“Cost benefit analysis for Euro 5 L-category noise emission”

Final results for presentation at  
UNECE/GRPB/TF-VS

April 4<sup>th</sup>, 2022 | IAI / Acustica

- Expert review and reassessment of cost benefit analysis for Euro 5 L-category noise emission
- Consortium comprising expertise in scrutiny, noise and traffic modelling
- Objective analysis of the 2017 CBA
- Reassessment using new data (Noise Source Ranking tests by TU Graz)
- To draw on ACEM (and other) expertise and inputs

Figure 5: Unit cost for road noise for four different countries and the recommended EC value from (WGHSEA, 2003)<sup>2</sup>.

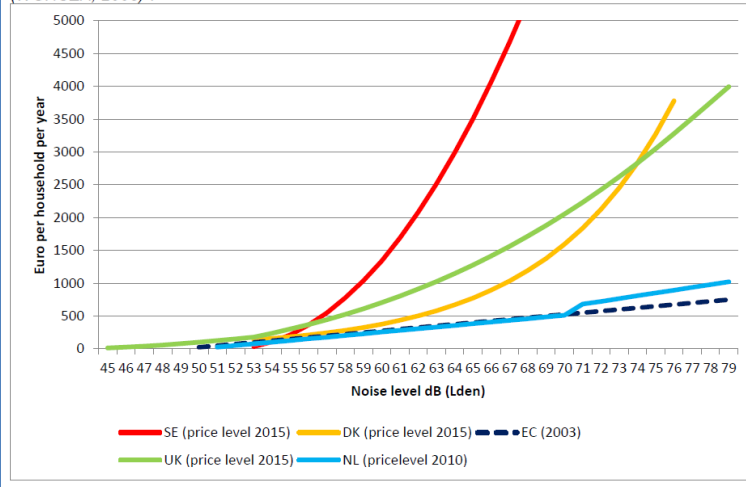
- CBA uses static valuations of benefits
  - Constant value per dB reduction
  - Based on 2003 study
- Dose-response curve not considered
- Subsequent studies update the state of the art
  - Higher costs per dB in general than EU valuation
  - Higher costs per dB at higher dB levels, reflecting scientific consensus
  - At low dB levels (e.g. some residential roads) comparable values to CBA

- Three countries have published dose-response curves
  - UK: WebTAG project built up over several years based on annoyance and health impacts
  - SE: hedonistic price study from one town (willingness to pay – disturbance and health effects)
  - DK: based on EU model, applying noise exposure factors for Denmark
- We apply these curves as scenarios for all European countries as an initial estimate

**Impact: significant increase in valuation of benefits**

Figure 27: Annual benefits for amenity and health and additional costs for R&D, production and enforcement, and totals, for 2 dB lower L-category sound limits, 2040 traffic noise levels, 0% illegal exhausts and no off-cycle noise and baseline market growth (BAU).

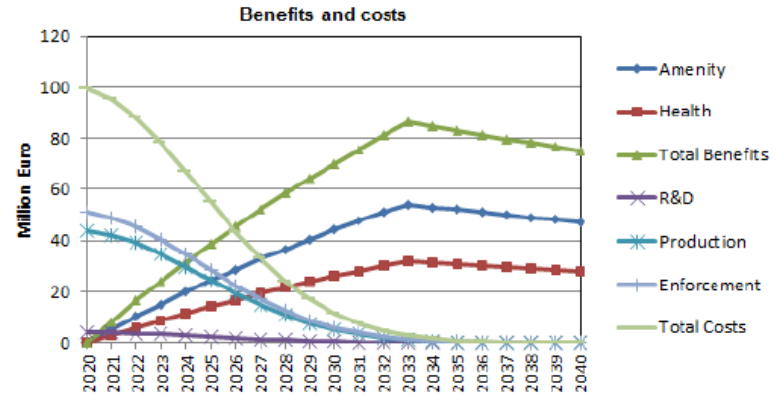
- The CBA figures indicate that costs approach zero around 2034
- This appears implausible since vehicles will still require noise-reduction components to be fitted
- Add-on costs for noise reduction can be expected to be valid out to 2040 and beyond
- Assuming cost incurred until 2040 → estimated increase by factor 1.65
